MEMORANDUM

From:	Built Heritage Officer	Service:	Green Infrastructure
Application No.	261891 + 261892	Site Visit Made:	No
Address:	URS Building, Whiteknights Campus, Earley, RG6 6BW.		
Proposal:	261891: Application for submission of details to comply with the following condition of planning consent 252389 dated 14/7/2026. Conditions 10 (Materials) and Condition 16 (Biodiversity). 261892 - Application for submission of details to comply with the following condition of planning approval 252302 dated 14.07.2026. Condition 10 relates to materials of external stair cores.		
Relevant built heritage condition text.	10. Materials of external stair cores Notwithstanding the details submitted, no works are to be undertaken in respect of the external stair cores and lift shaft until full details and a physical sample of the aluminium cladding with the textured perforations, along with a physical sample of the material has been submitted to and approved in writing by the local planning authority. The development shall then be carried out in accordance with the details as approved.

Submitted photo of cladding material sample

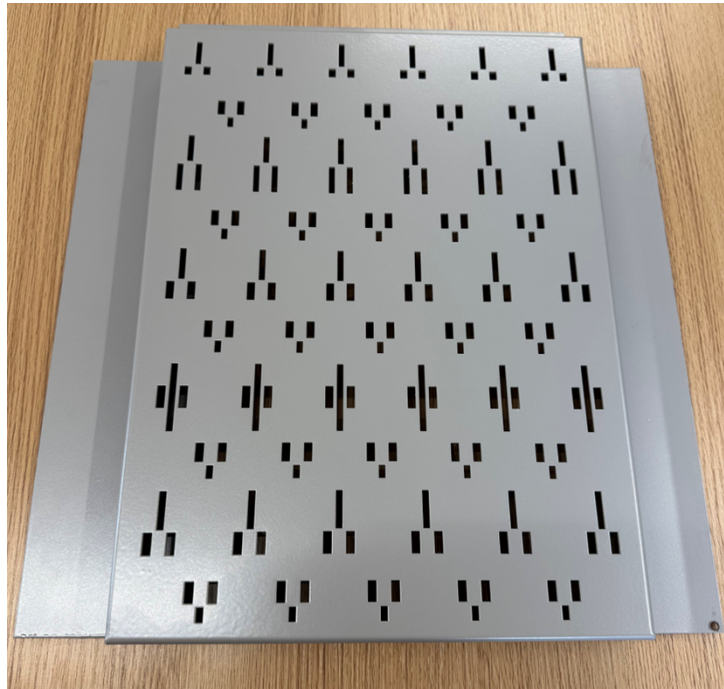
In terms of the physical sample the aluminium cladding with decorative perforation pattern to be used on the new stair and lift towers confirms the intended silver-grey coloured powdered coated finish to the cladding along with the size and configuration of the perforations to the cladding.

Whilst there is no provided scaling is shown in the photograph of the sample panel on a desk-top that would establish the relative size of the perforations in the panelling, which from the faux timber graining of the desk-top would appear to suggest these perforations to be relatively small (estimated to be around 5mm wide, with the longer elements being some 30mm long) and as such seemingly be quite small in size. Furthermore, the accompanying submitted drawing WW033-2360383-ACG-A-SKE260603-003 Rev.3: Proposed Stair Core, shows the arrangement of the perforations and their regularity to change over the length/height of the towers, with

the sample panel being thought to be representative of those cladding panels with the densest concentration of perforations to them. Also as shown on the drawing the perforations to the cladding would appear to be larger than that of the sample.

Acceptable for the condition to be considered to be met in full.
